ADDENDUM 2 – JOB 26

TO: All prospective bidders on project ITS-8-094(089)352 & SS-9-999(342), Job No. 26, scheduled for the October 9, 2015 bid opening.

2015 ESS & ATR IMPROVEMENT - EAST

ATR Details
 I-29 northbound
 RP 196.57
 Site 243
 Bowsmont

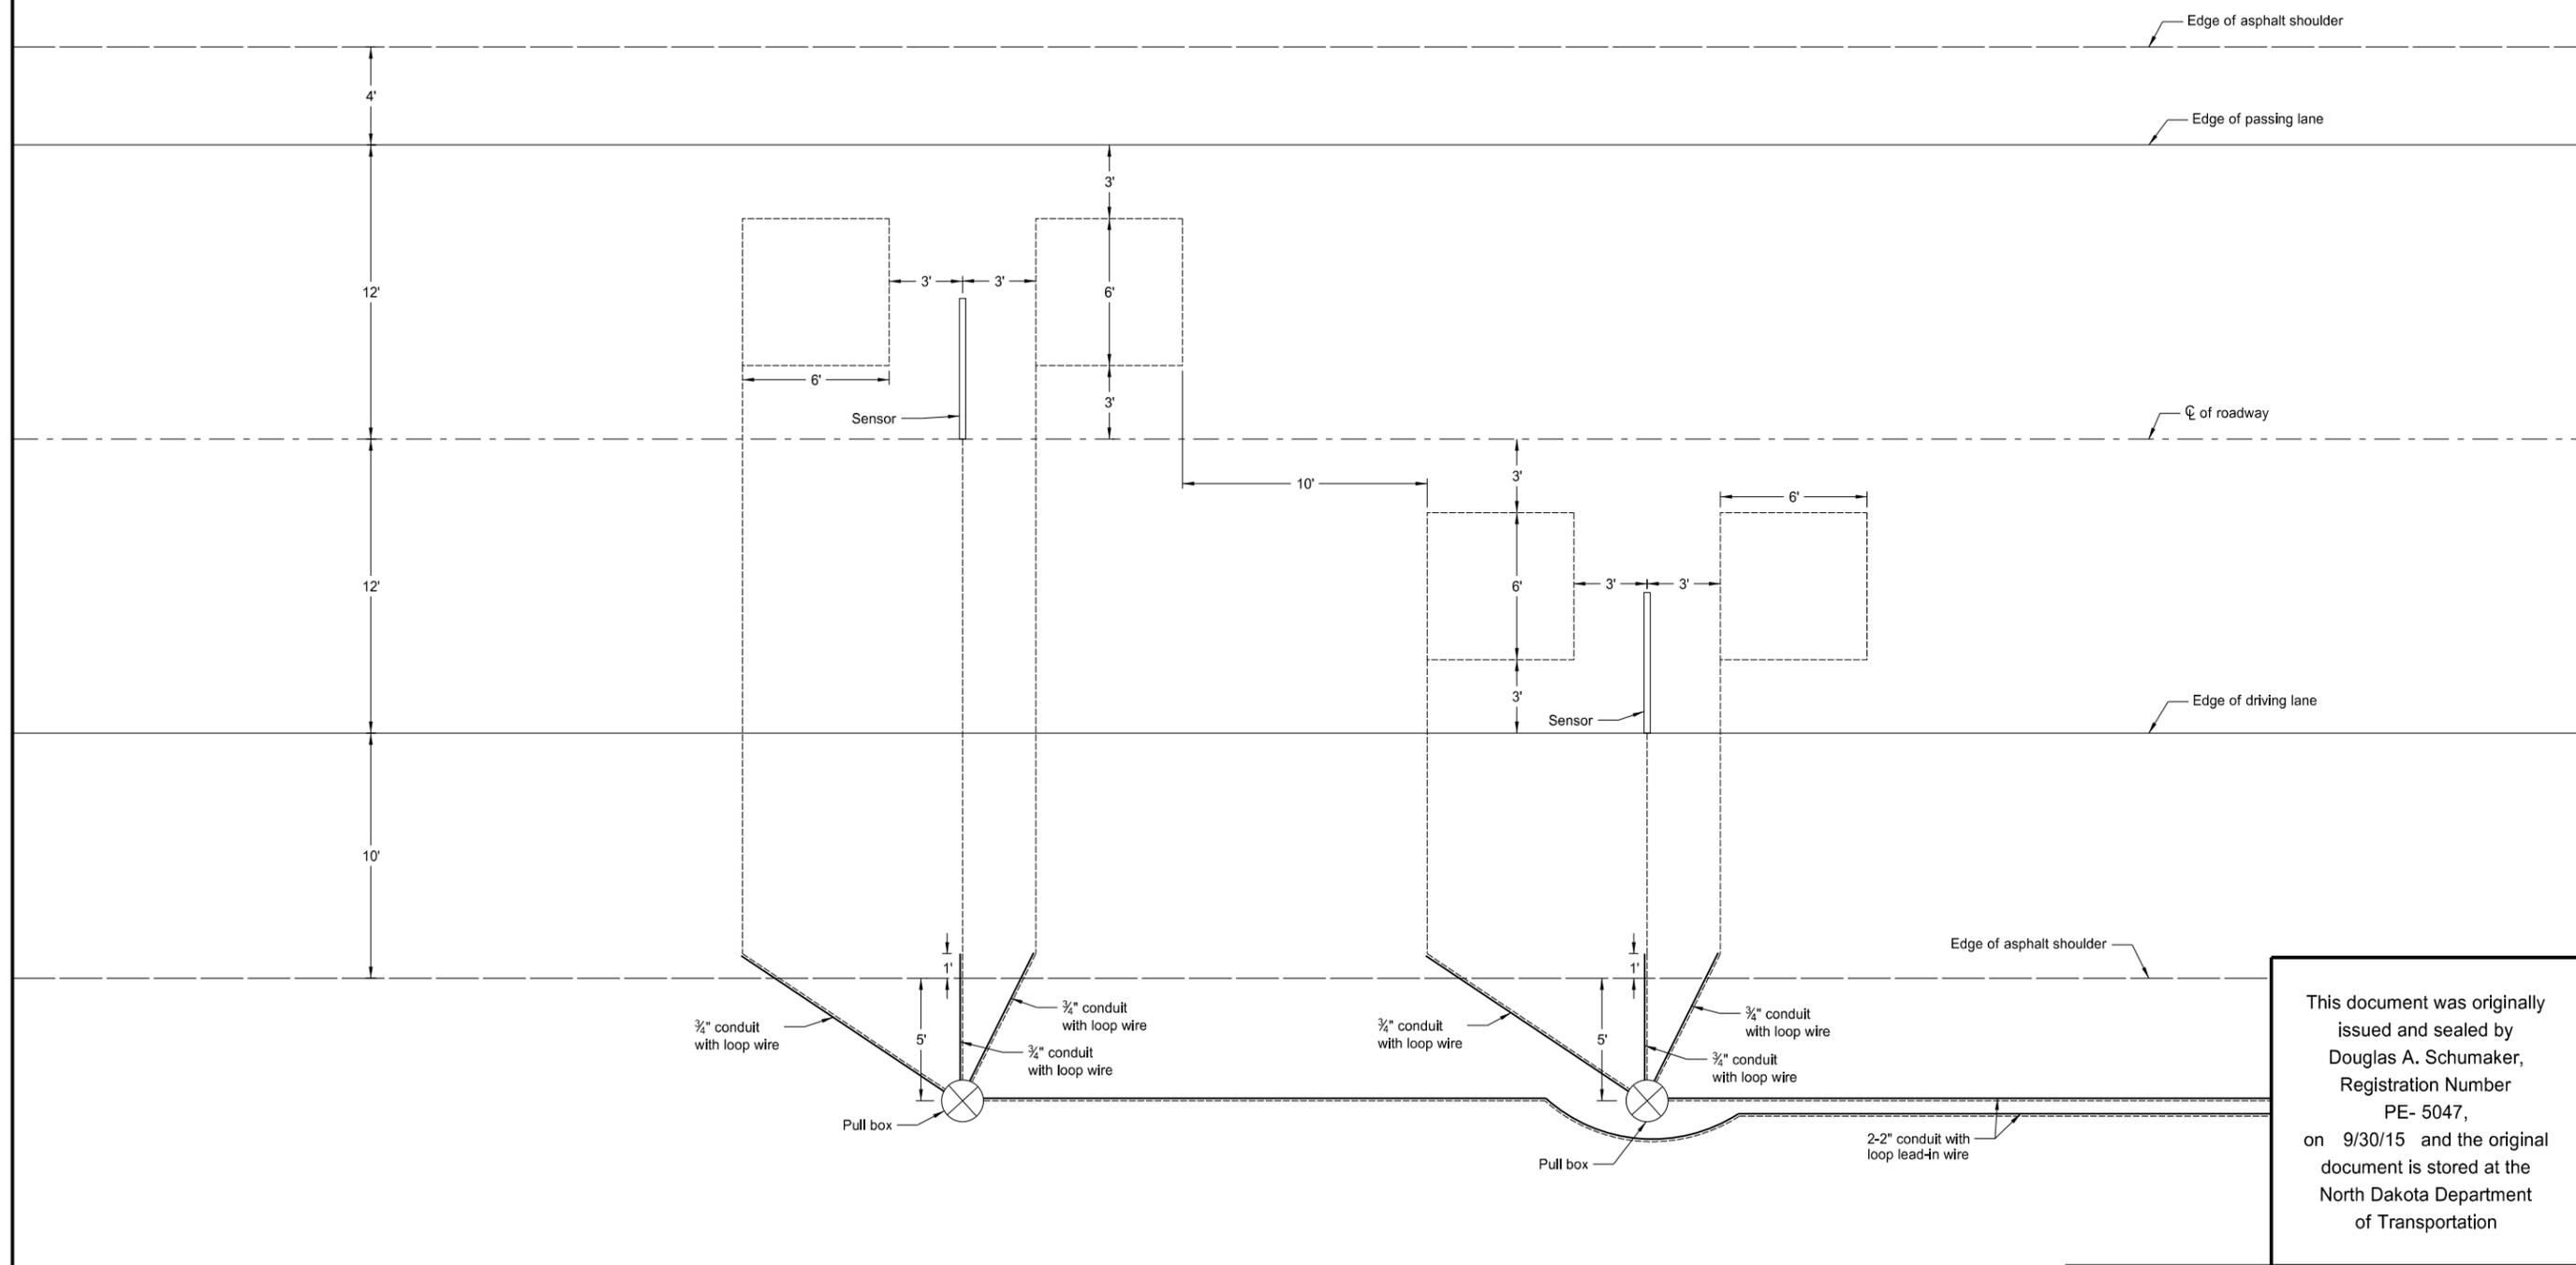
Sheets 150-10D through 10F:

ATR Site 243 near Bowesmont has been added. The existing ATR site requires new loops and sensors in the northbound lanes. Detail sheet and quantities table are included.

ATR Recorder Cabinet
with Concrete Foundation
Site 229

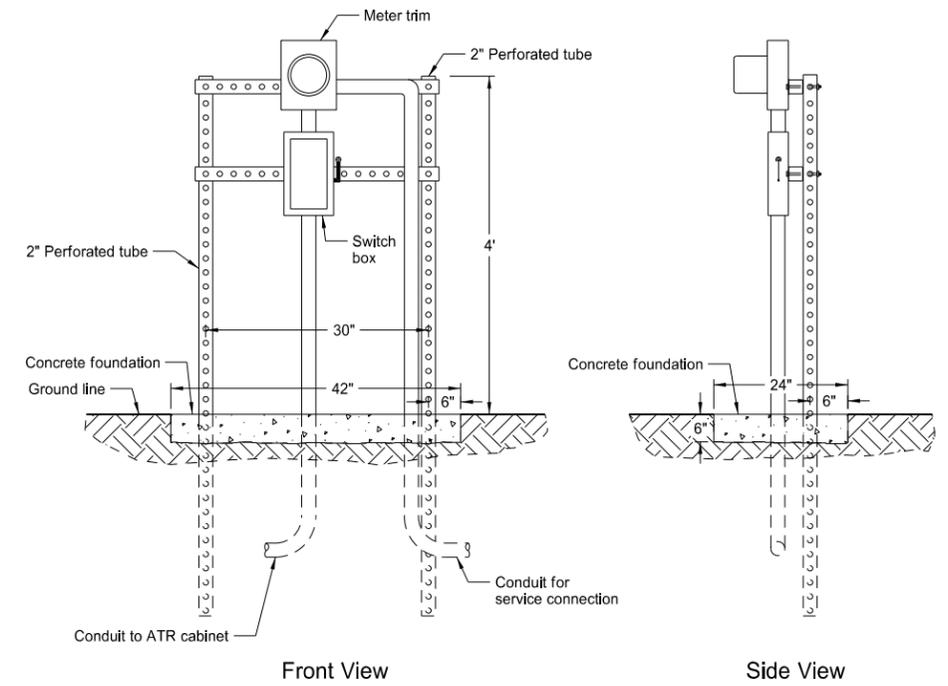
Sheet 150-17:

Recorder cabinet with switch box detail has been added for Site 229.
